STAFF RECOMMENDATION
945 S Douglas Avenue, Unit #17
March 17, 2021

Application: New Construction – Infill/Part II SP
District: Waverly-Belmont Neighborhood Conservation Zoning Overlay
Council District: 07
Base Zoning: SP
Map and Parcel Number: 105130289.00
Applicant: Martin Wieck, Nine12 Architects
Project Lead: Jenny Warren, jenny.warren@nashville.gov

Description of Project: This is an application for the construction of an infill structure as part of a part II historic review of an SP zoning.

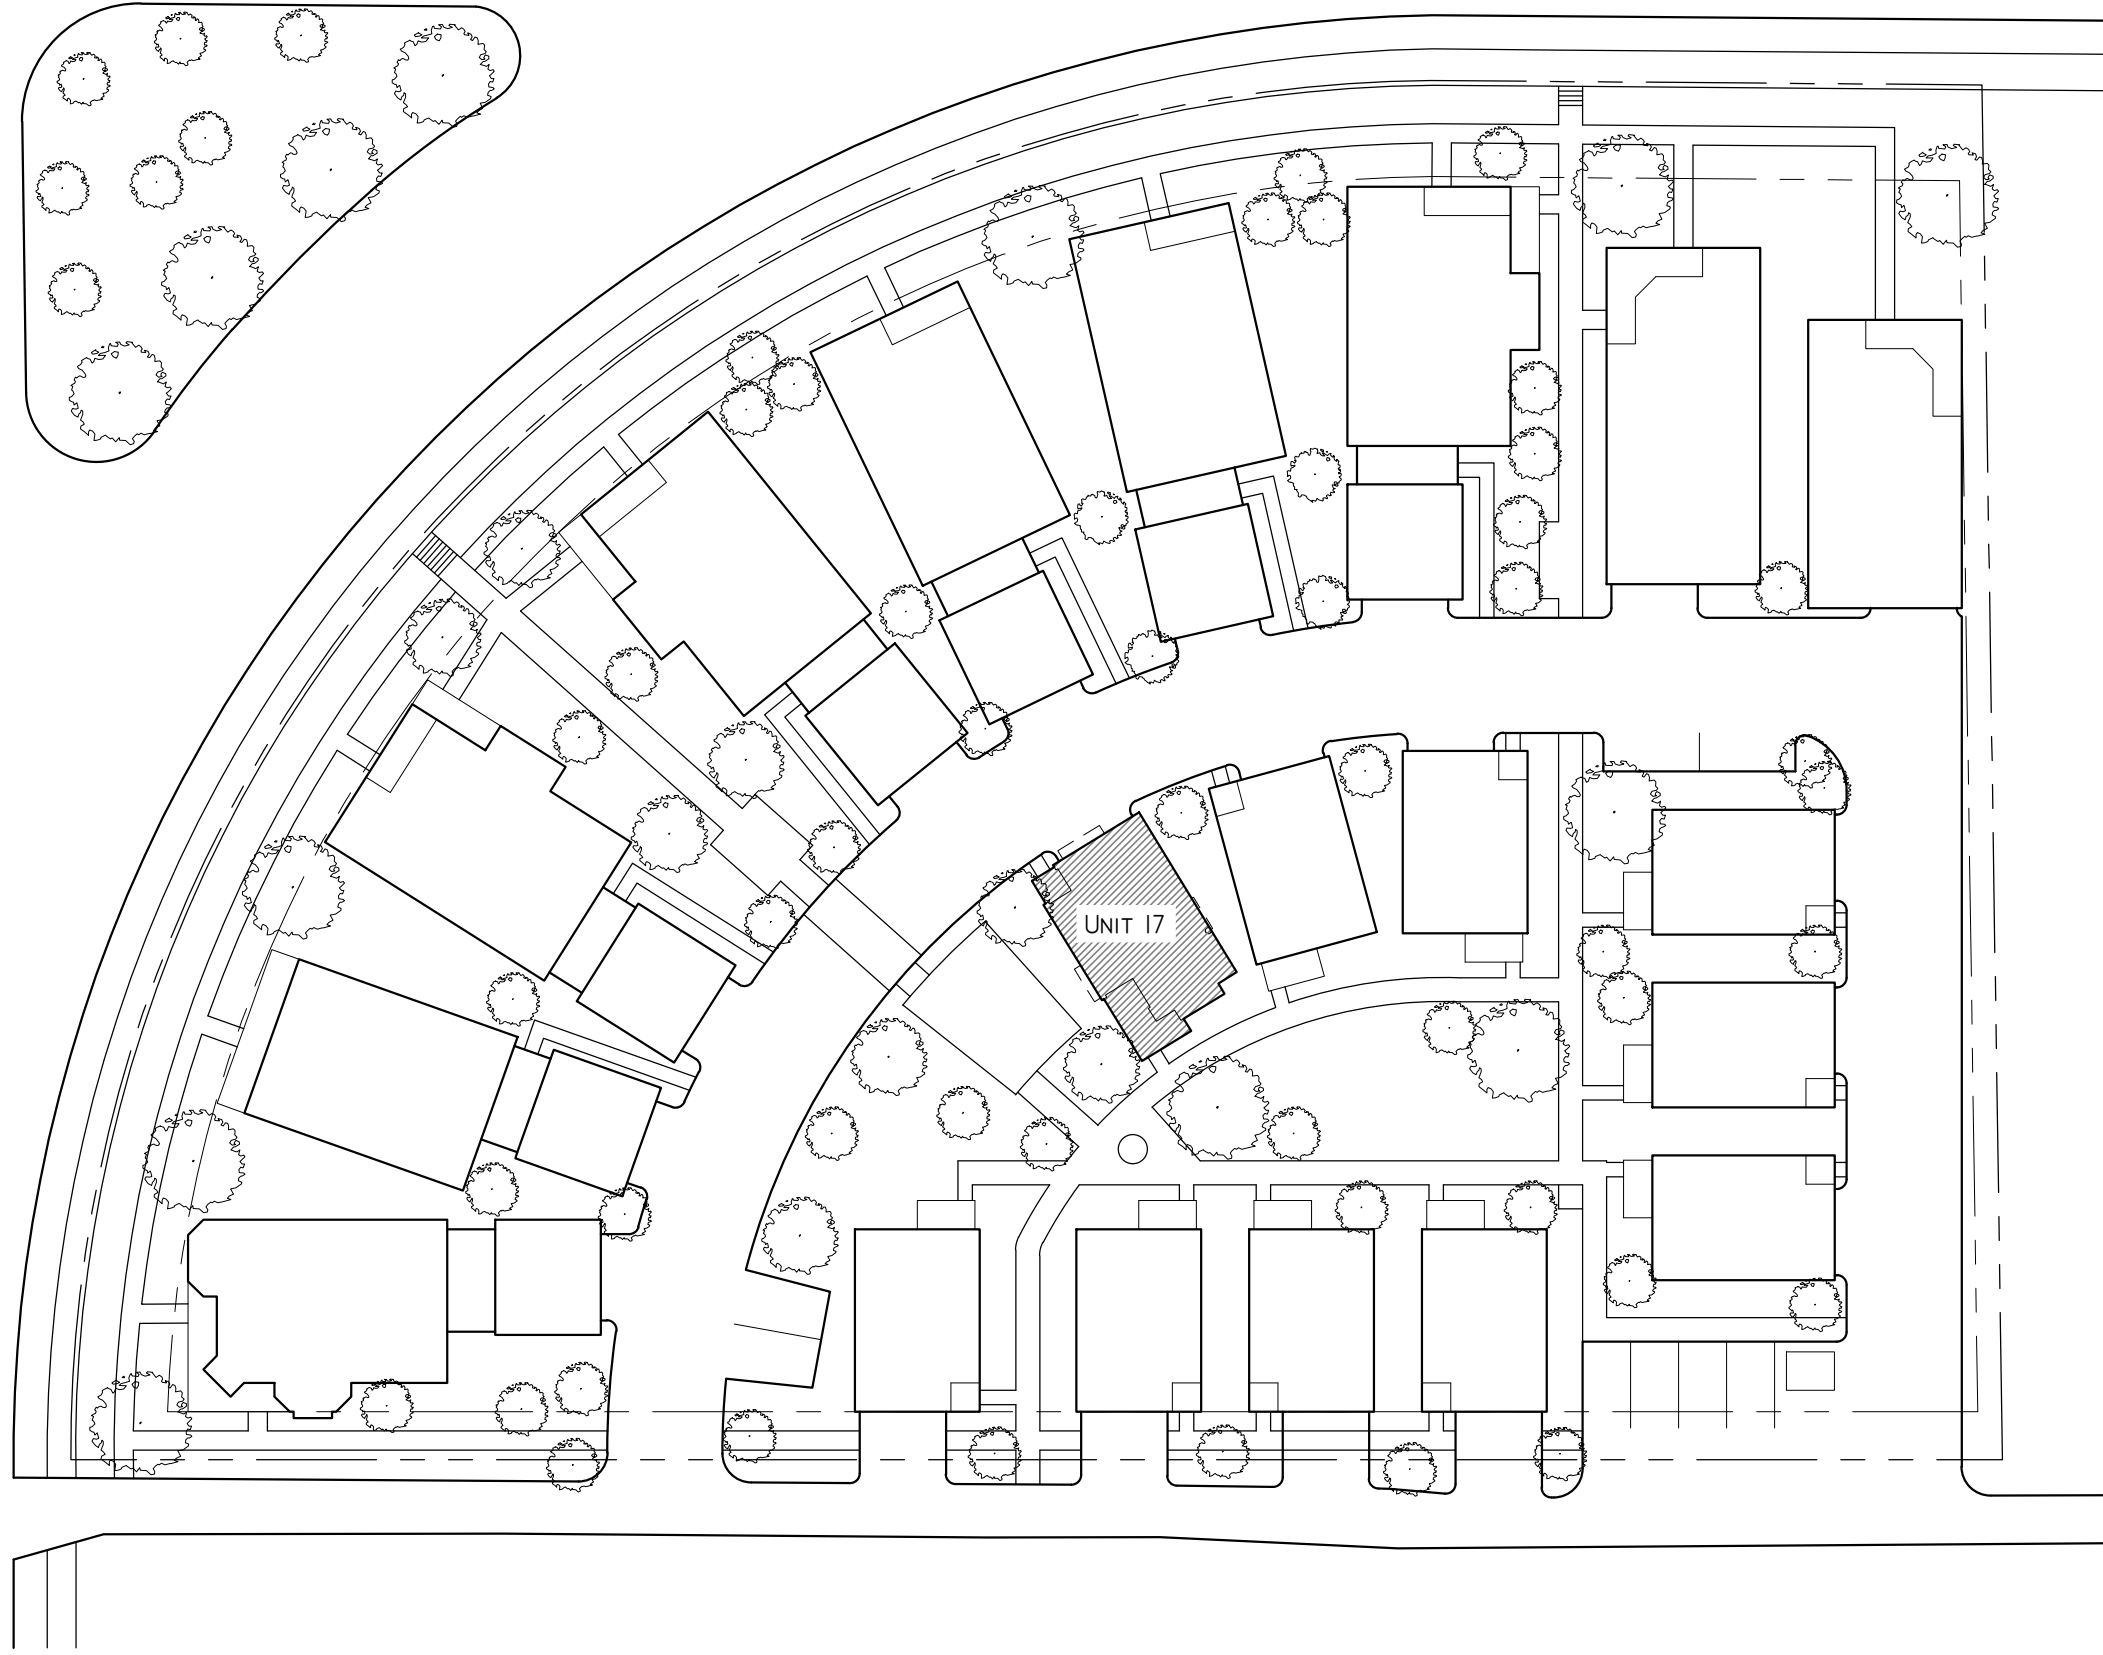
Appurtenances & Utilities: The location of the HVAC and other utilities was not noted. Staff asks that the HVAC be located on the rear façade, or on a side façade beyond the midpoint of the house, and that utility meters be located on the side of the building, within five feet (5') of the front corner or on the rear or rear-side within five feet (5') of the rear corner. Alternative mechanical and utility locations must be approved prior to an administrative sign-off on building permit(s). The project meets section III.I. for new construction-utilities and III.J. for new construction-public spaces.

SP SITE PLAN

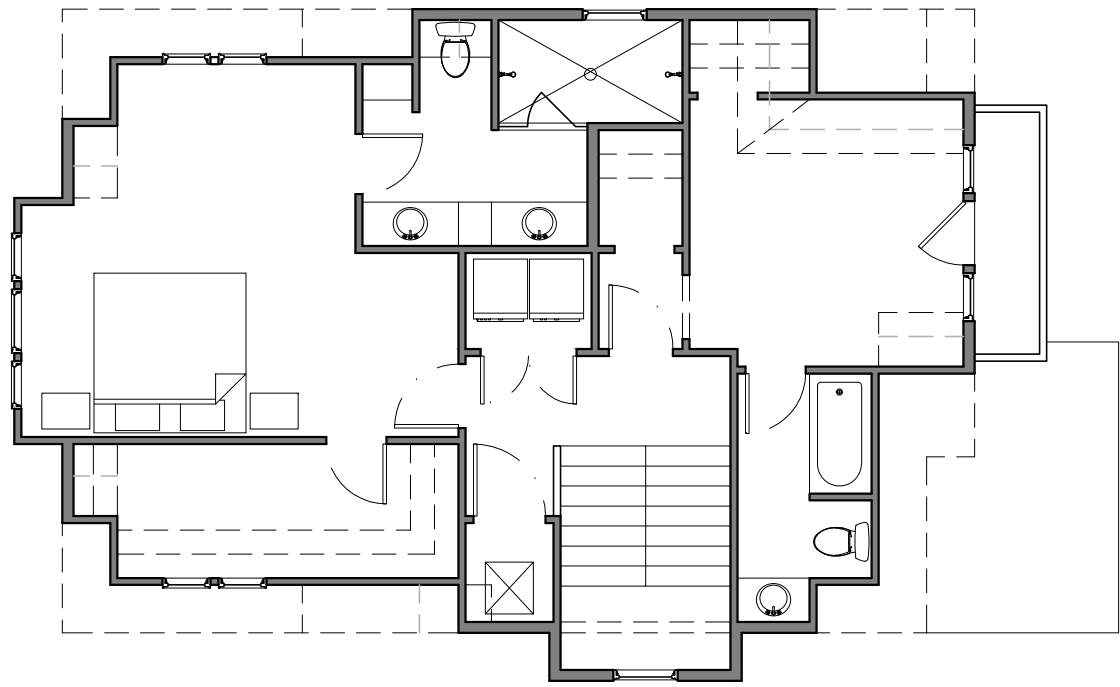
Setback & Rhythm of Spacing: The infill is entirely interior to this parcel and does not have applicable setbacks to the street/side property lines/alley. The Commission has commonly considered projections that might not be at-grade in the determination of appropriate setbacks. Each elevation includes an additional bay which projects another several feet. Except on the south elevation, these bays are cantilevered. The applicant has verified with the Planning Department that adding these bays to the approved footprint does not require a revision to the SP.

In terms of the rhythm of spacing: at the closest point, the unit is about five feet (5') away from the unit to the right as viewed from the courtyard. To the left is a walkway. This matches what was approved.

The project meets the SP approval and section III.C for setback and rhythm of spacing for new construction.

3 THIRD FLOOR PLAN
SCALE: 1/8"=1'-0"

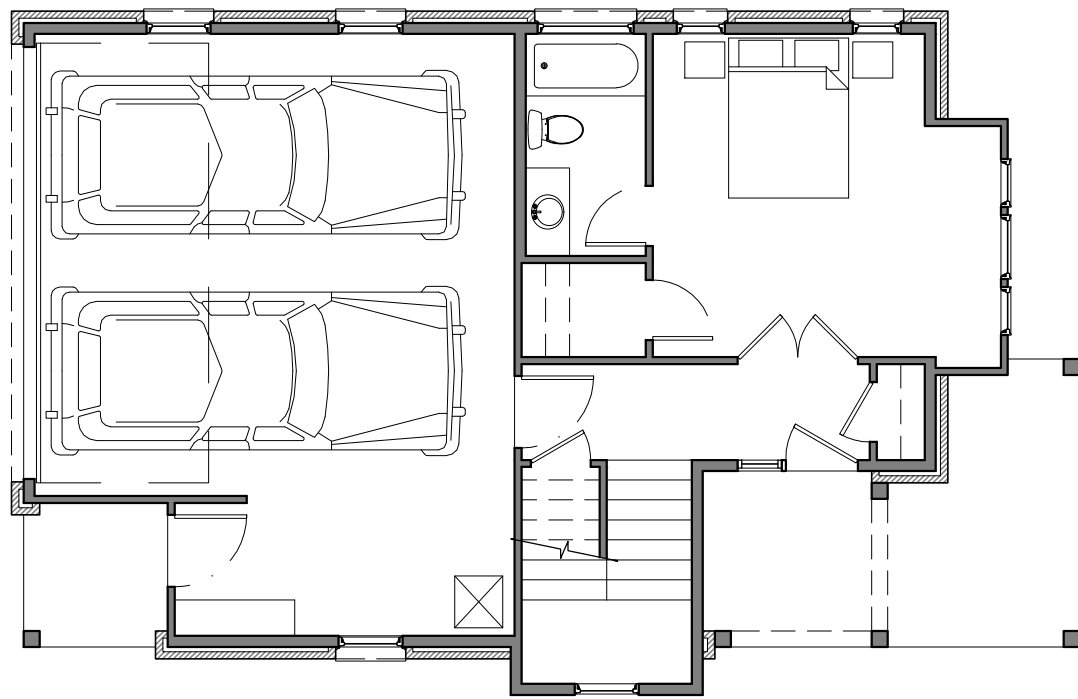
Form, Height & Scale: The interior units were approved by MHZC to be two and one-half stories; however, Metro Council required that the buildings not exceed two stories as part of their approval of the rezoning request. The proposed ridge height is thirty-five feet (35'), with eaves measuring nineteen feet, eight inches (19'8"), matching the form approved by the MHZC as part I of the SP. The proposed form includes a third half-story, evident through the proposed cross-gable form, multiple dormers and a third-level balcony, which does not meet the SP as approved by Council.

Roof Shape: The applicant was encouraged to use multiple roof forms across the development to create variety and avoid a homogenous streetscape; however, this is one of the interior buildings that does not directly relate to the streetscape. The approved form showed the half story as being primarily roofing with a dormer but what is proposed is a cross gable, with multiple dormers and a small third level balcony. A mix of a cross gable with dormers is not a historic roof form and balconies are typically not found on the

third level. Staff recommends removal of the third story and a revision of the roof form to meet the requirements of the SP and the design guidelines.

1. The height shall be revised to be no more than two stories tall to meet the requirements of the SP;
2. The roof form be redesigned to be more aligned with historic roof forms and meet section III.E;
3. Staff shall review and approve the brick sample, roofing color, doors, garage door, porch floor and walkway material, prior to purchase and installation; and,
4. The HVAC shall be located on the rear façade, or on a side façade beyond the midpoint of the house, and utility meters shall be located on the side of the building, within five feet (5') of the front corner or on the rear or rear-side within five feet (5') of the rear corner;
